ADDENDUM NO. 2

**ITB 25-FAC-0017 – Building Improvements @ Dwight D. Eisenhower School
3700 Tall Pines Drive
New Orleans, LA 70131**

Architect's Project No. M25-001

For Owner: Orleans Parish School Board

2
A3.2
NEW STAIRS AND SIDEWALKS AT PLAY GROUND
SCALE: 1/2"=1'-0"

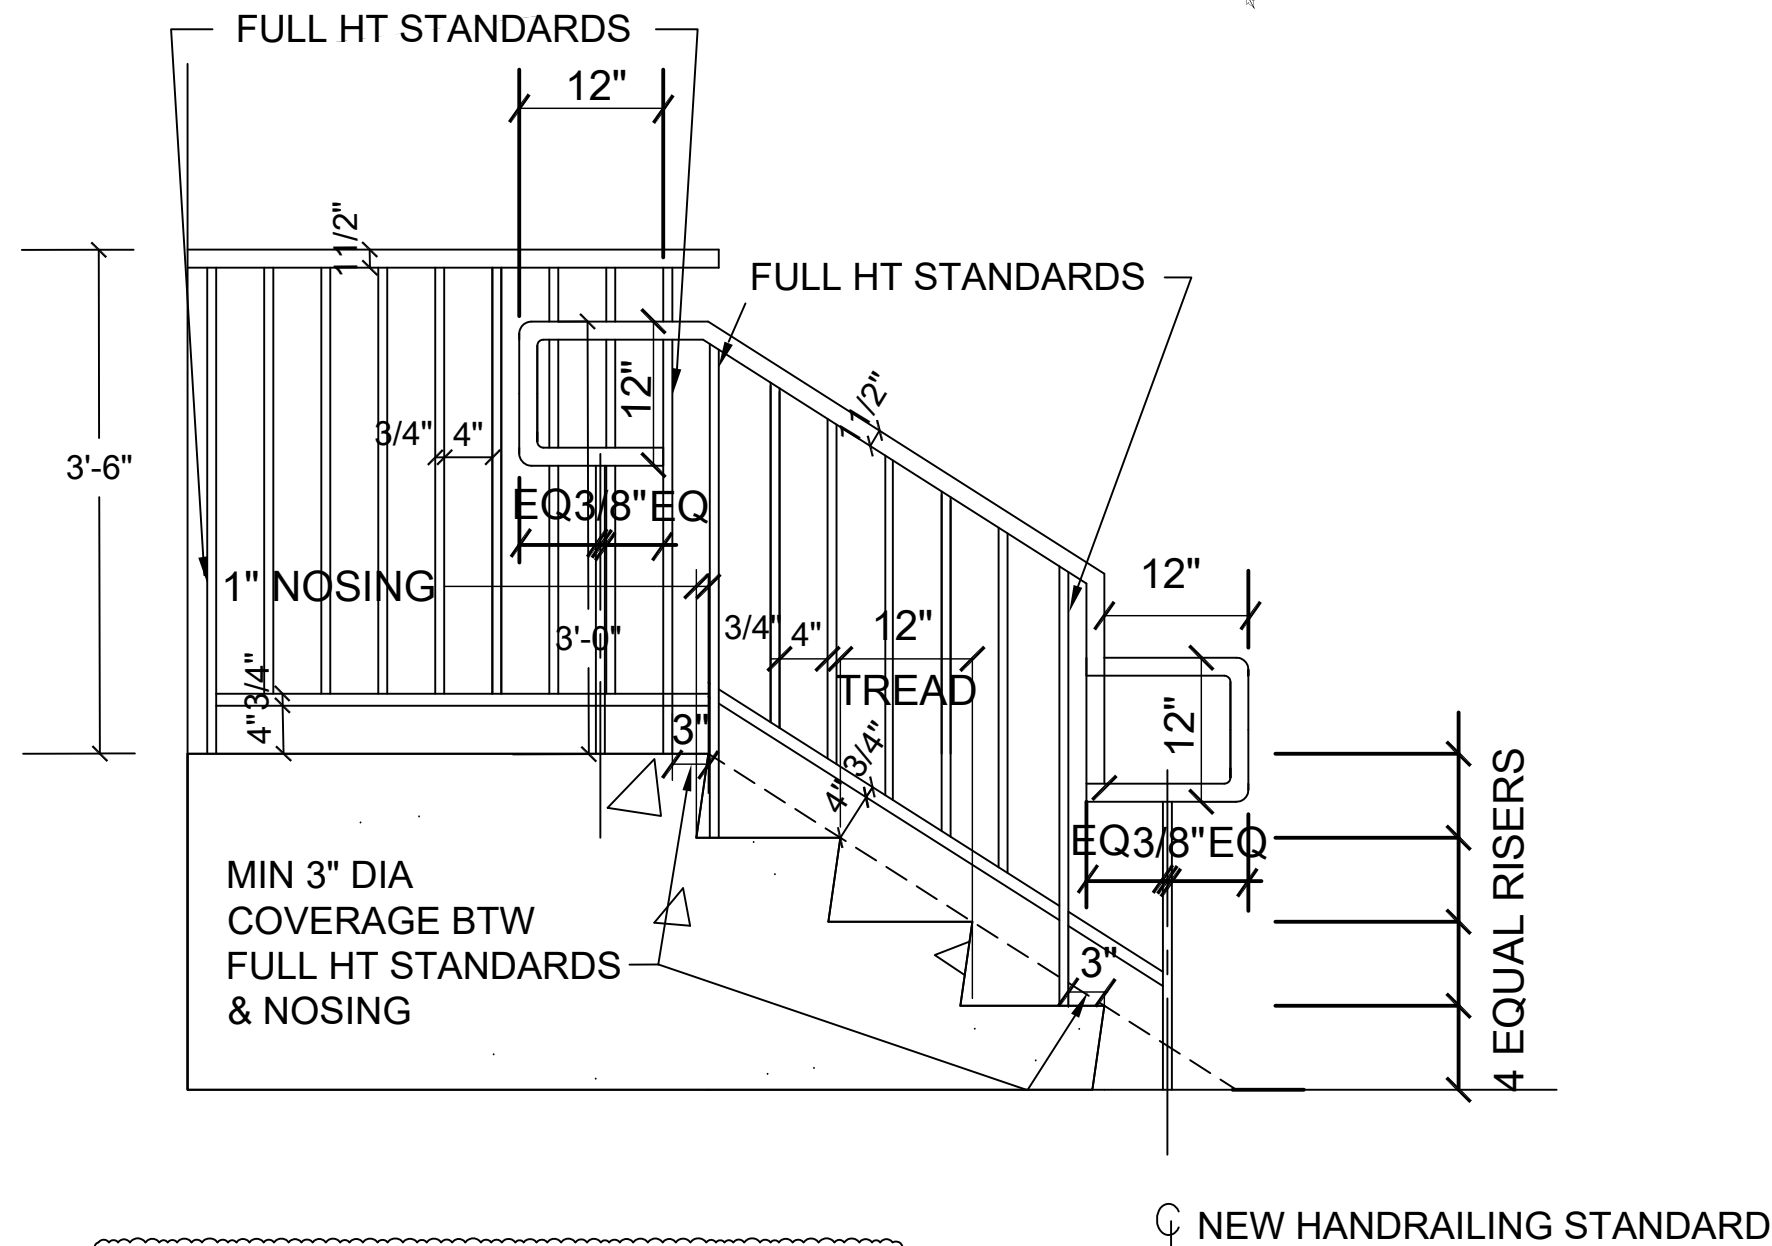
4. Question: Can you confirm the total length of railing to be installed?

Answer: We did a quick tally, but these numbers are not to be used in lieu of the bidder's own tally of what we show in the construction documents. 36" handrailing: 169'-0", 42" guard railing: 160'-4.1/2".
